Solicitation Addendum

Addendum No.: 2
Solicitation No.: 18-TA002764JP
Project No.: 6086160
Solicitation Title: Rye Road Functional Improvements and Master Lift Station
Addendum Date: June 11, 2018
Procurement Contact: Joe Pretorius, johannes.pretorius@mymanatee.org

STRUCTURAL REHABILITATION EYE ROAD BRIDGES @ MULL CREEK BRIDGES #134025 & #134026

RYE ROAD BRIDGES
OVER MILL CREEK
STRUCTURAL REHABILITATION

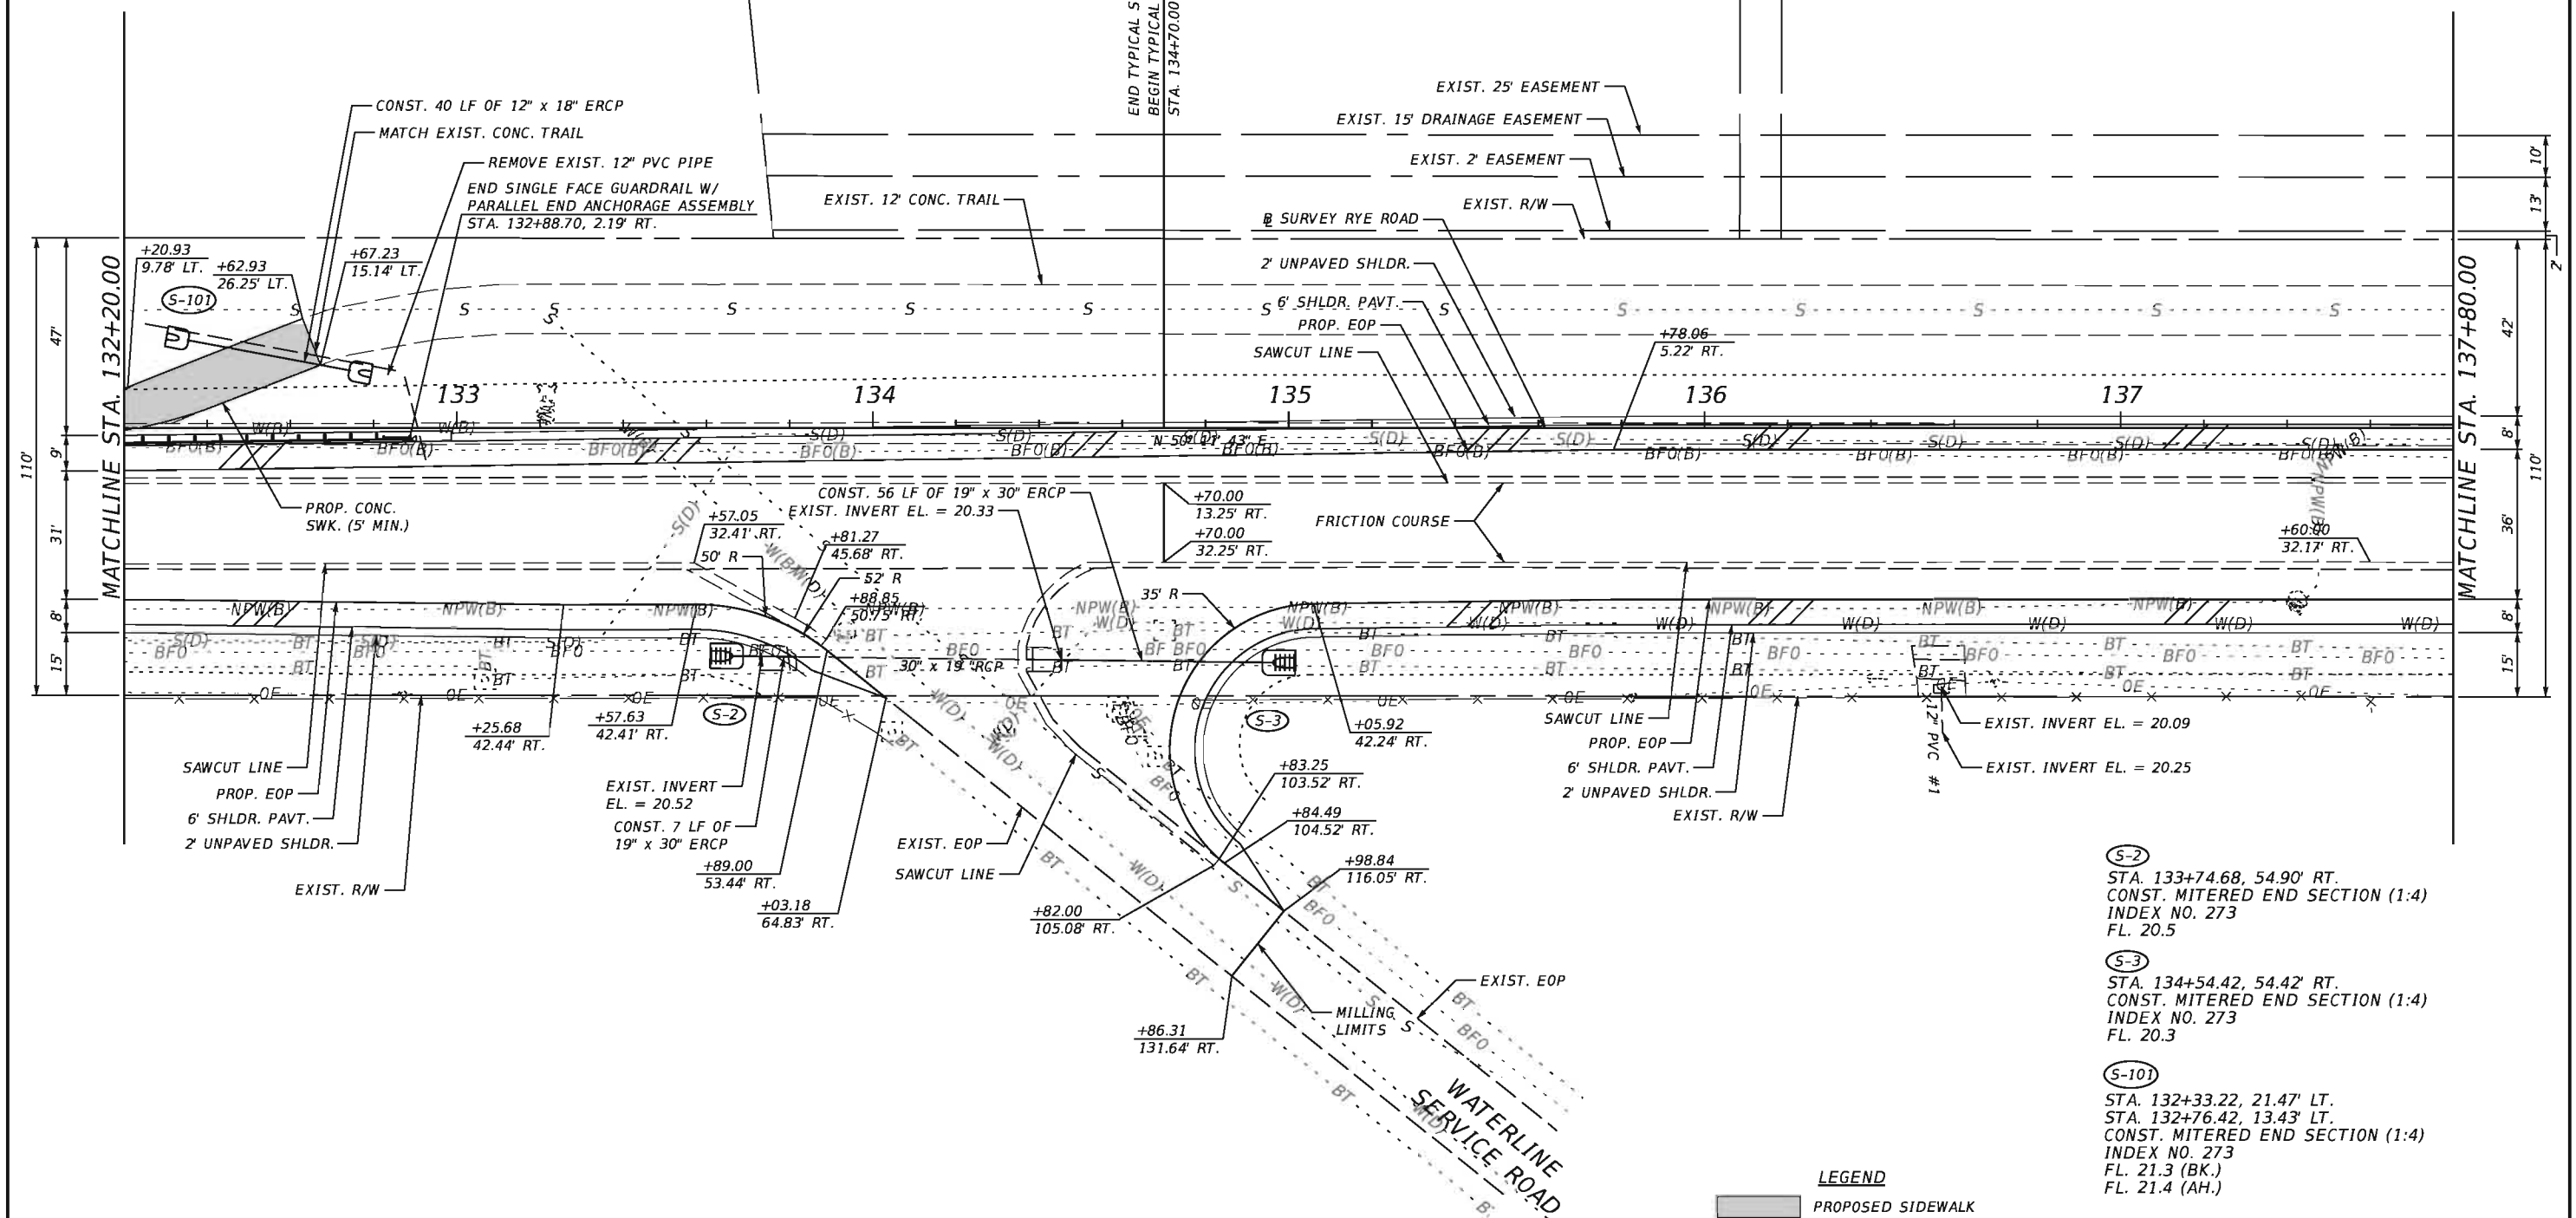
9. Sheet No. 15 - Roadway Plan (7) – Existing pipe sizes added; removal of existing pipe added [Question 18]
10. Sheet No. 17 - Roadway Plan (9) – Existing pipe sizes added; removal of existing pipe added [Question 18]

Q18. Referencing the General Notes, note #10 states, "All existing drainage structures, underdrain systems, ditches and ponds are to remain unless otherwise noted". There are no call outs for any of the existing drainage pipe to be removed where it appears that the pipe should be removed. How do we determine what is to be removed and what is not? Please clarify.

R18. Where new sidewalk construction / excavation impacts existing drainage pipes, the intent is to remove the existing pipes. Removal callout notes have been added to the plans per this Addendum No. 2.

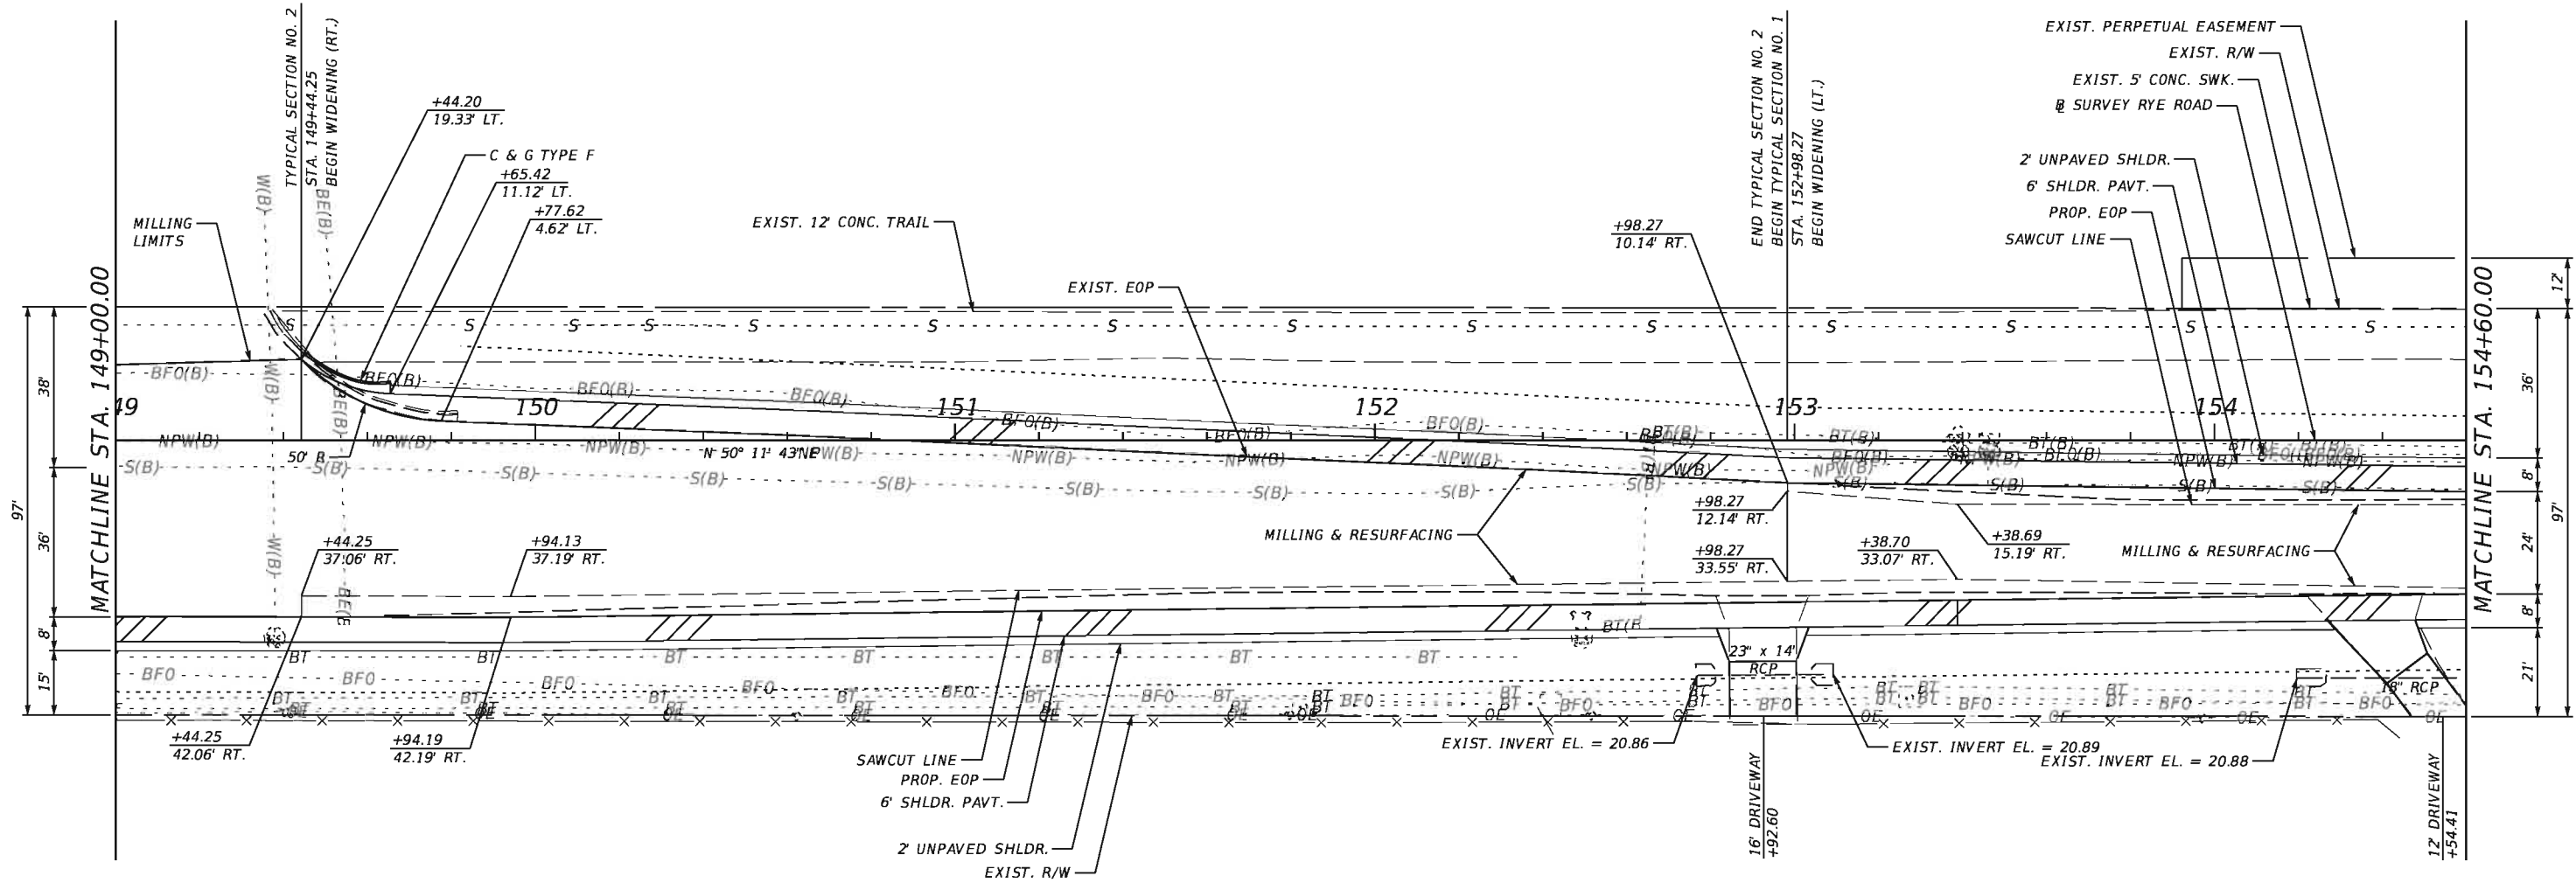
11. Sheet No. 18 - Roadway Plan (10) – Existing pipe sizes added [Question 18]
12. Sheet No. 20 - Roadway Plan (12) – Existing pipe sizes added; removal of existing pipe added [Question 18]

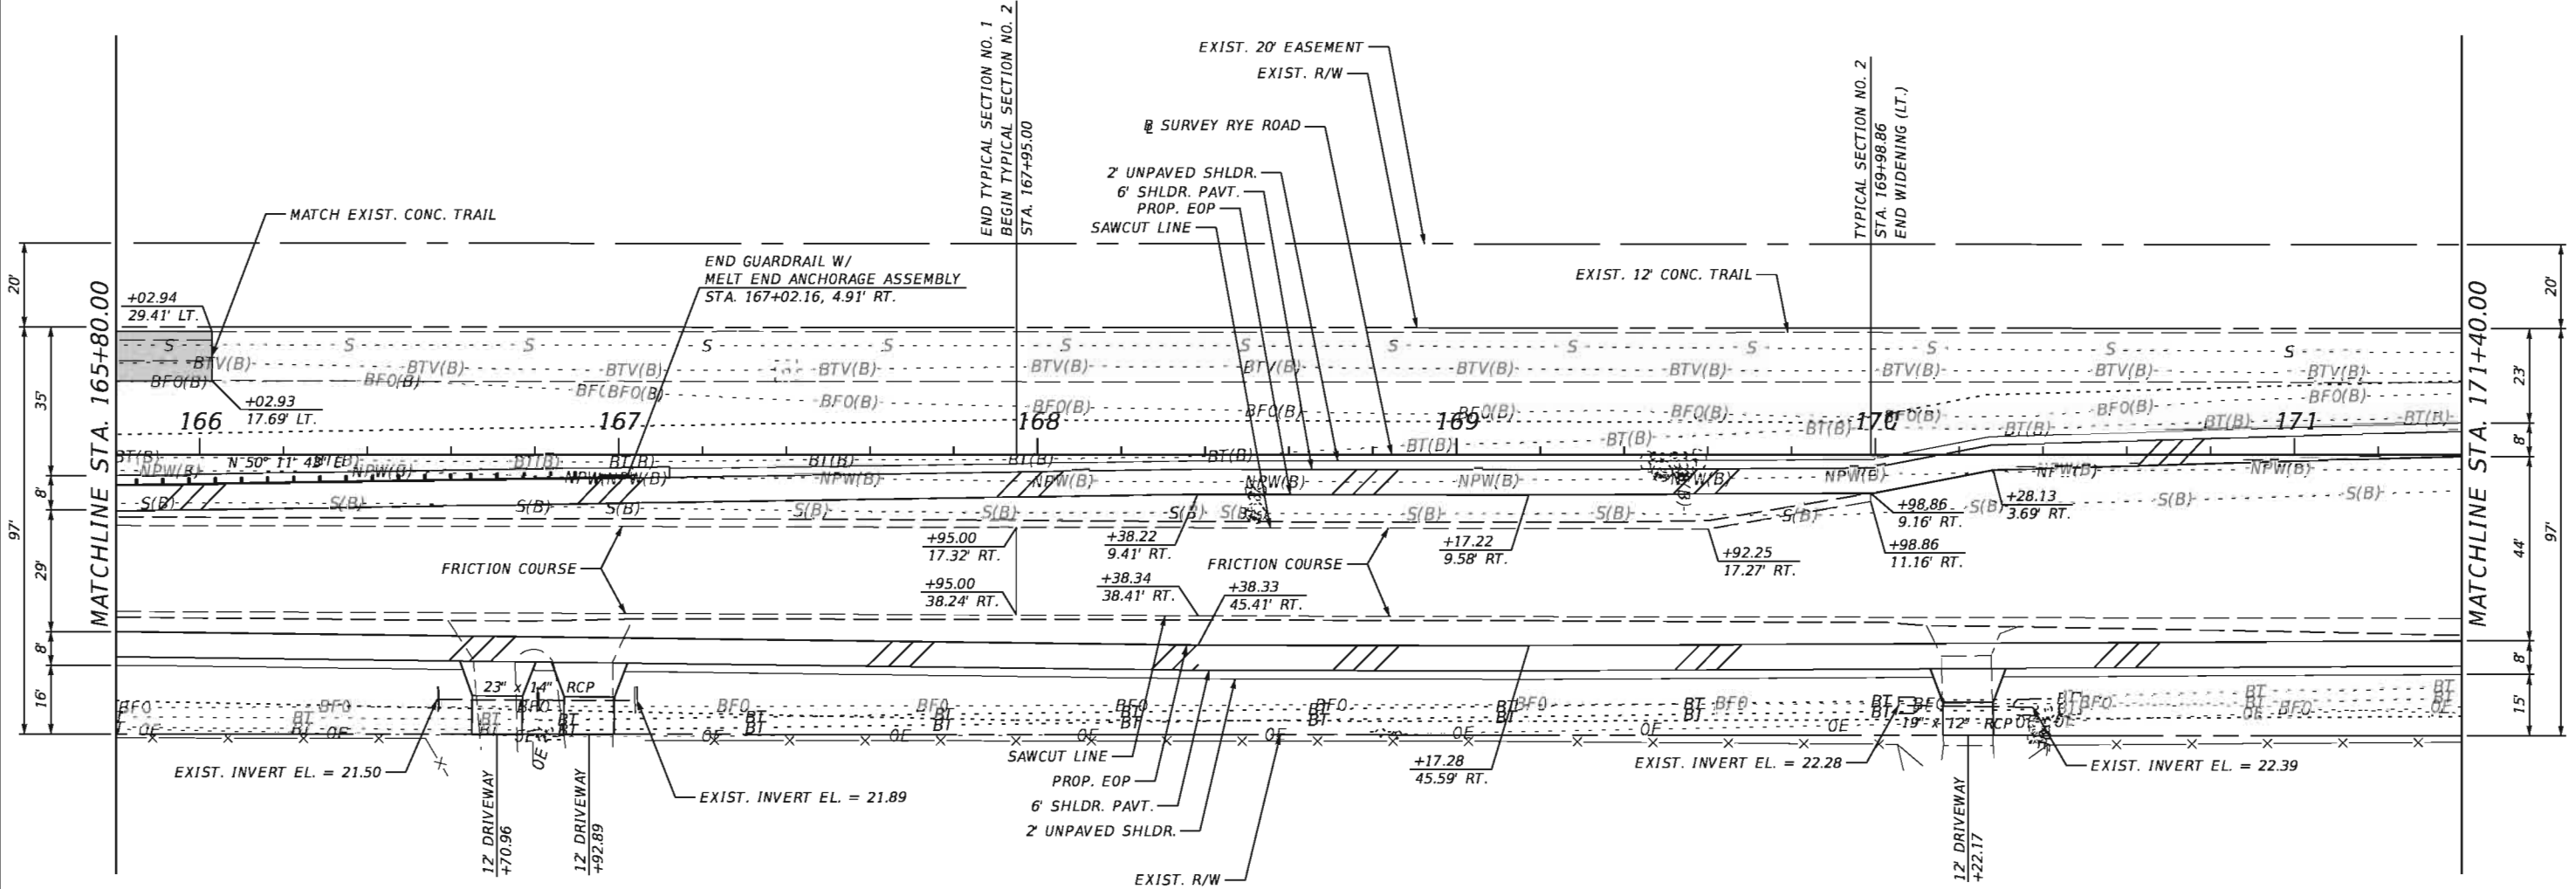
13. Sheet No. 21 - Roadway Plan (13) – Existing pipe sizes added [Question 18]
14. Sheet No. 22 - Roadway Plan (14) – Existing pipe sizes added [Question 18]

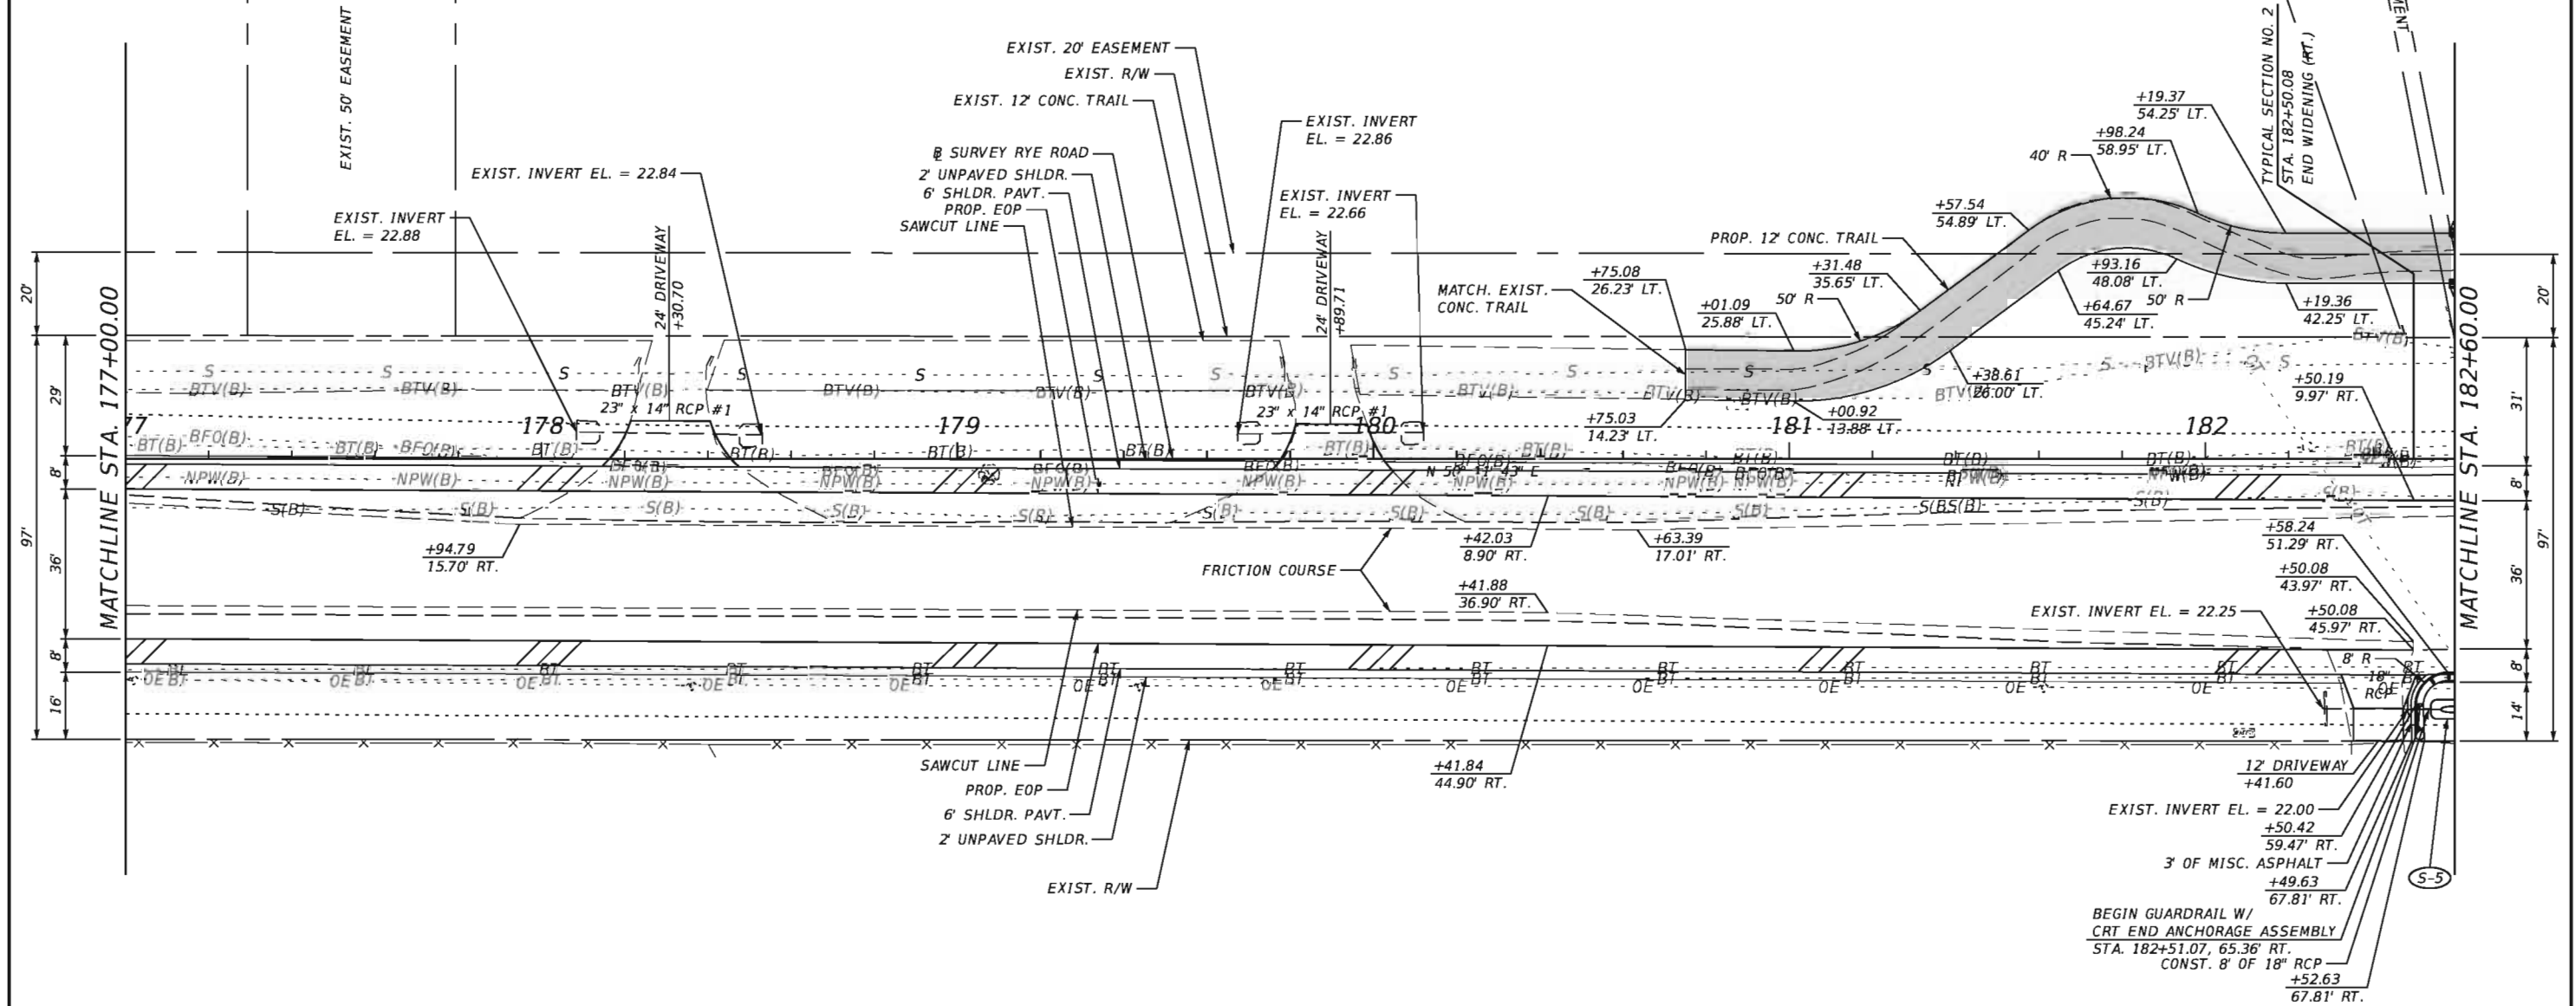
15. Sheet No. 23 - Roadway Plan (15) – Existing pipe sizes added [Question 18]
16. Sheet No. 24 - Roadway Plan (16) – Existing pipe sizes added [Question 18]
